File Number: 8-A-25-IH

Meeting: 8/20/2025
Applicant: Tony Nelson Master Plan Builders and Design
Owner: Gregory and Wilhelmenia Yarborough
District: Lonsdale Infill Housing Overlay District

Location: 3305 Savoy St. **Parcel ID:** 81 P A 012
Zoning: RN-2 (Single-Family Residential Neighborhood)
Description:
New primary structure.

Level III New Primary Structure

FRONT ELEVATION
SCALE: 1/4" = 1'-0"

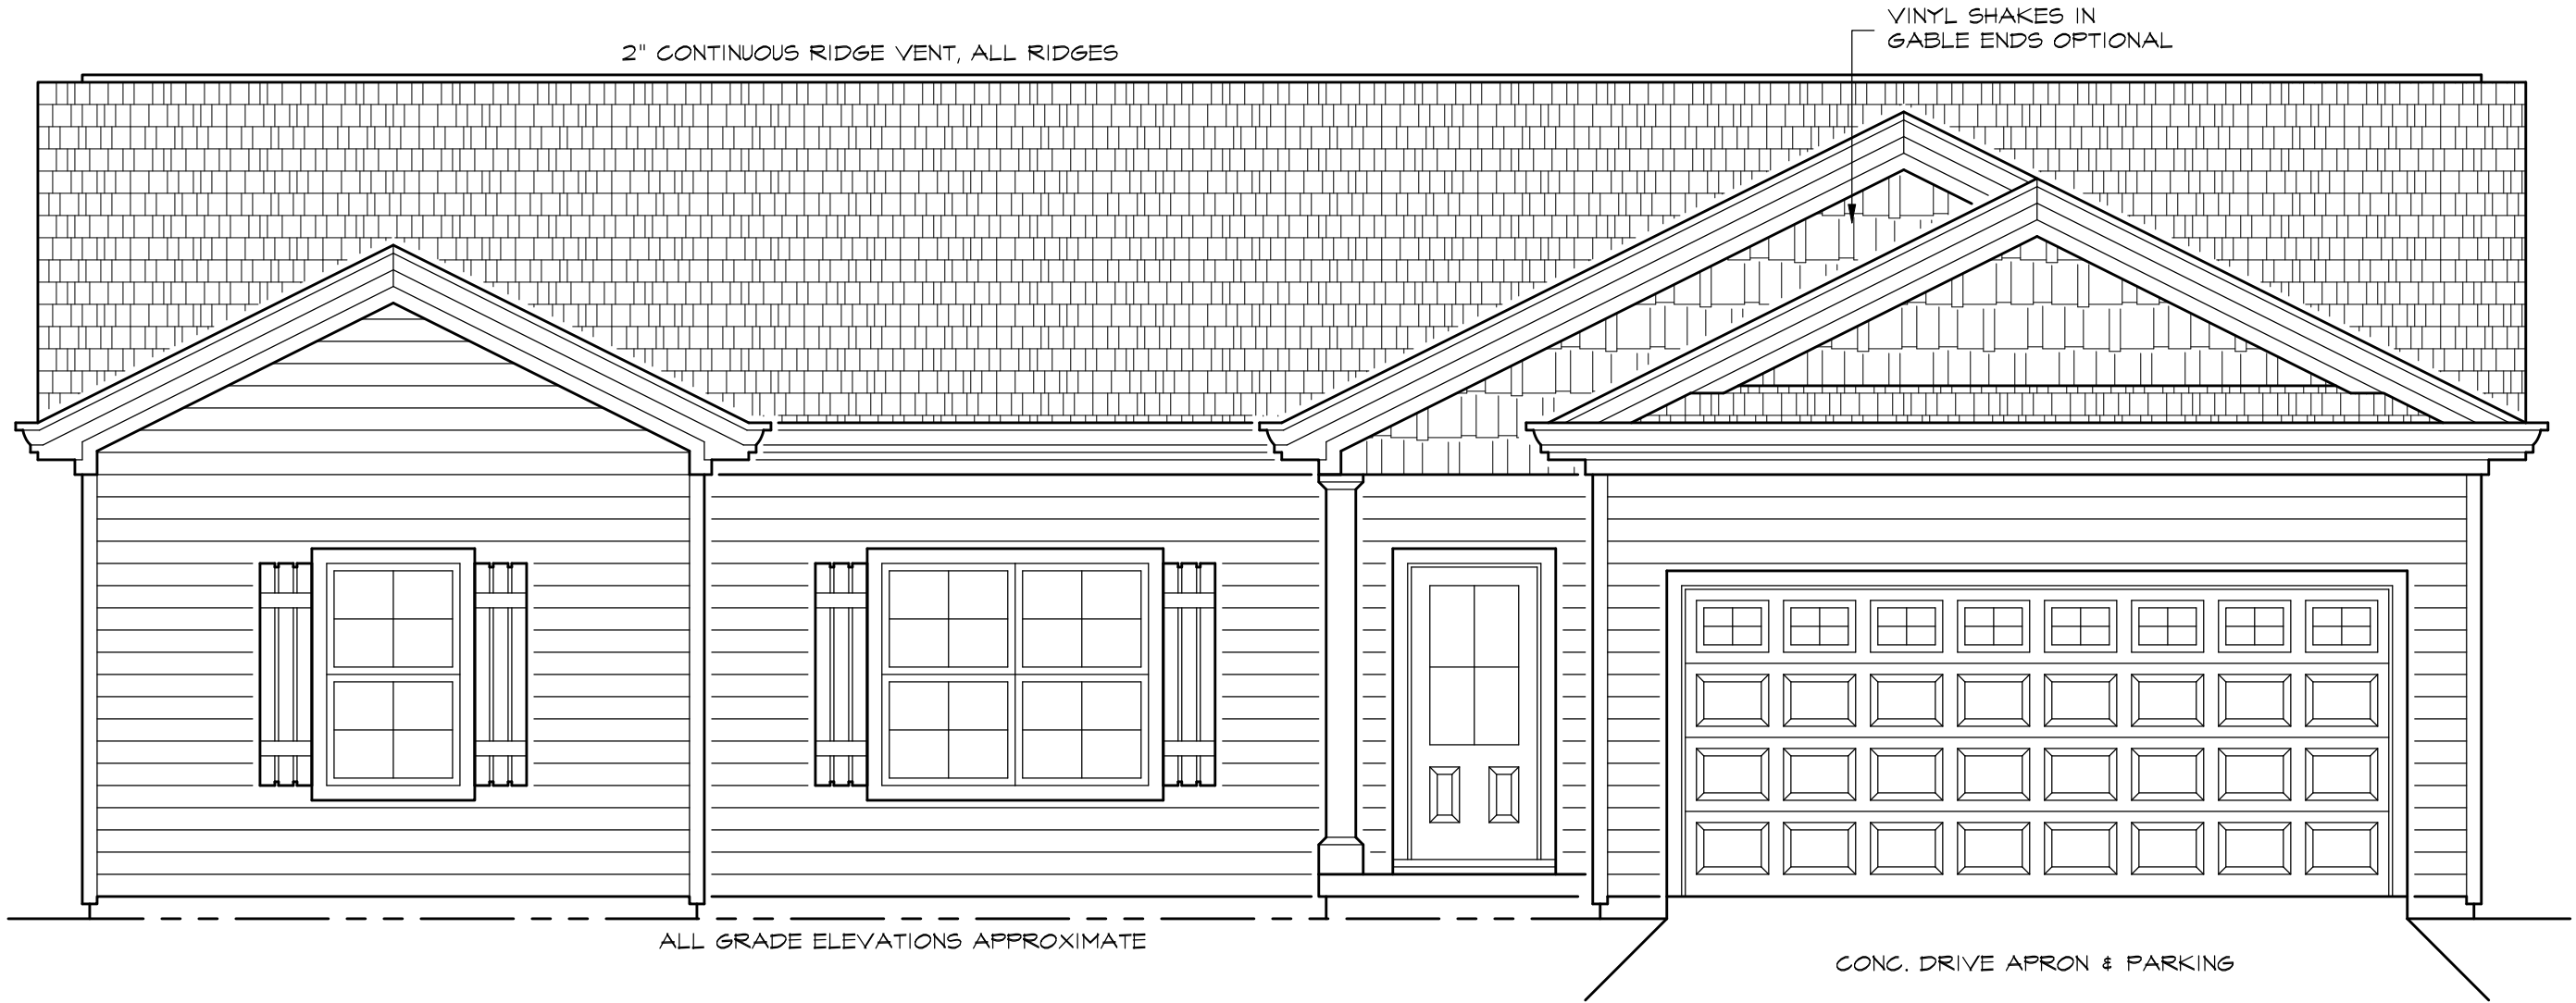
5. The four-bay, one-story façade is similar in height to the context, but it is significantly wider in scale.

6. The design features a 6' wide by 8' deep stoop recessed under the front-gable massing shared with the garage. The guidelines recommend that new construction feature porches with proportions and supports similar to the context, allowing for stoops where porches are not traditional. The stoop should be widened to be a partial width porch supported by two columns.

7. Guidelines recommend window and door styles be similar to historic houses on the block with a similar ratio of solid to void. The proposed half-lite paneled front door is appropriate. The 4/4 single-hung and 1/1 single-hung windows are compatible with the context, and the façade and rear elevation feature a sufficient ratio of solid to void. However, the fixed window on the right elevation should be revised to be single-hung, and a window should be added to the left elevation, to be approved by staff.

ROOF LAYOUT PLAN
SCALE: 1/8" = 1'-0"

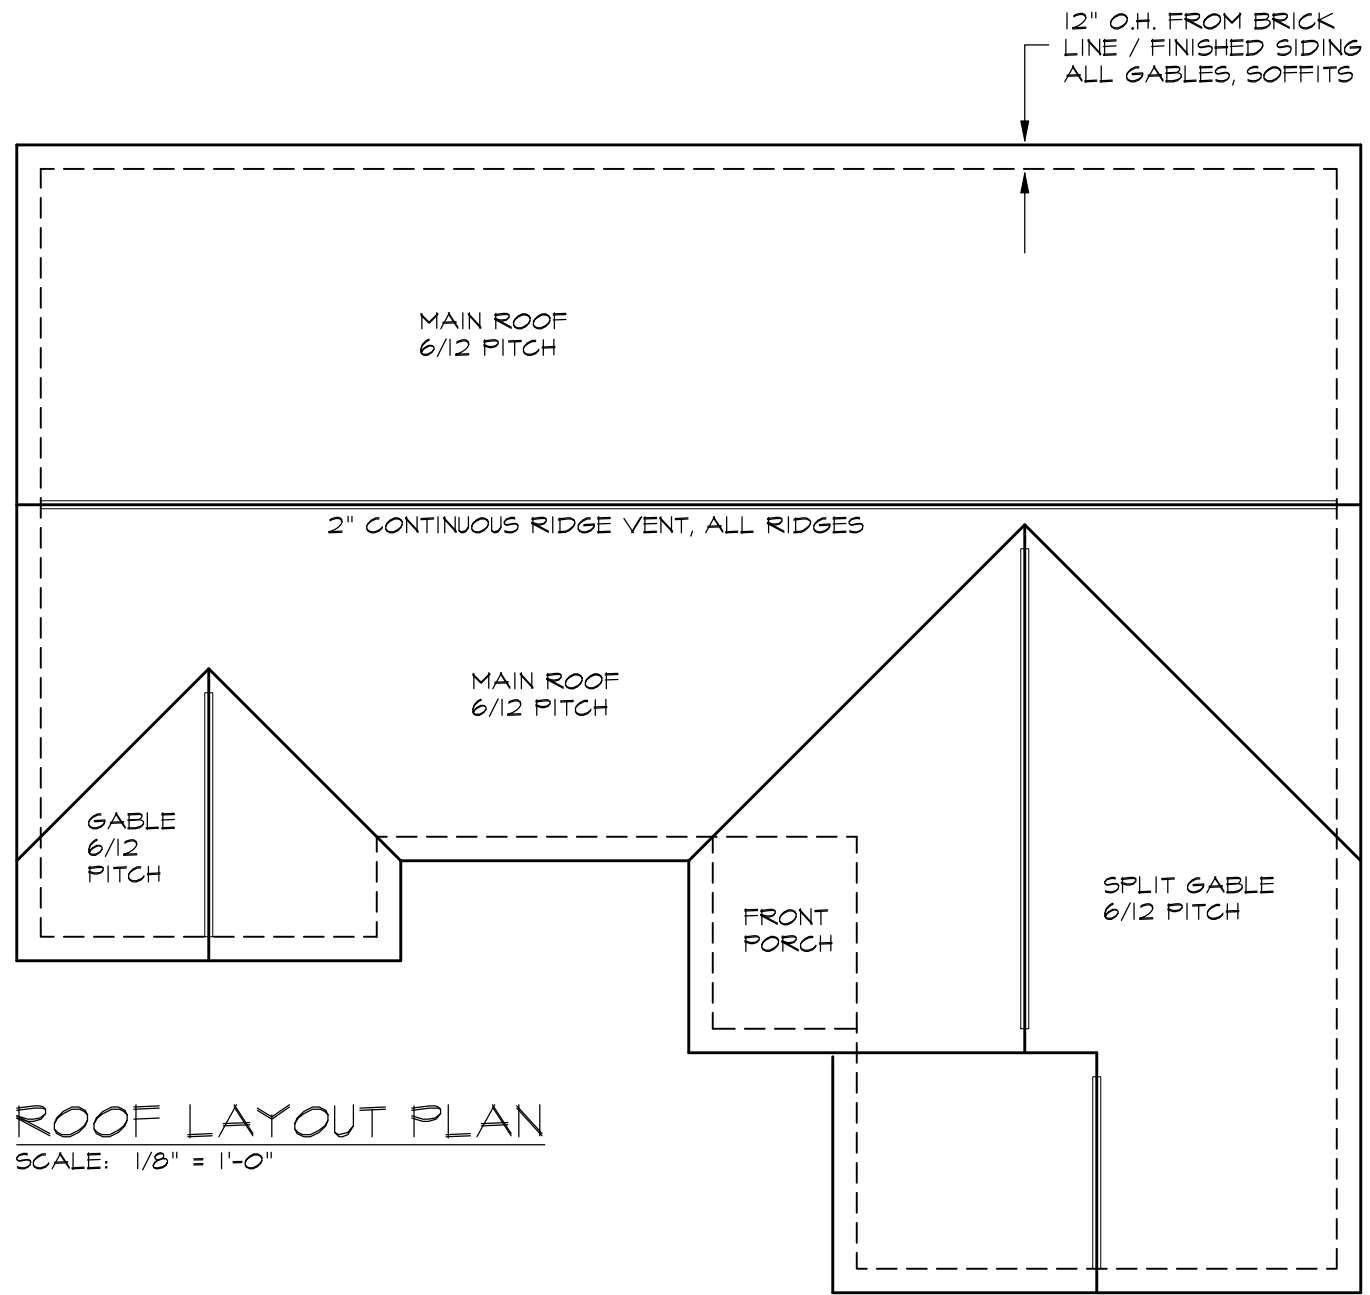
8. The 6/12 pitch side-gable roof is the minimum typically approved by the design guidelines, and the design benefits from the partial cornice returns and rake mold trim, which should be retained.
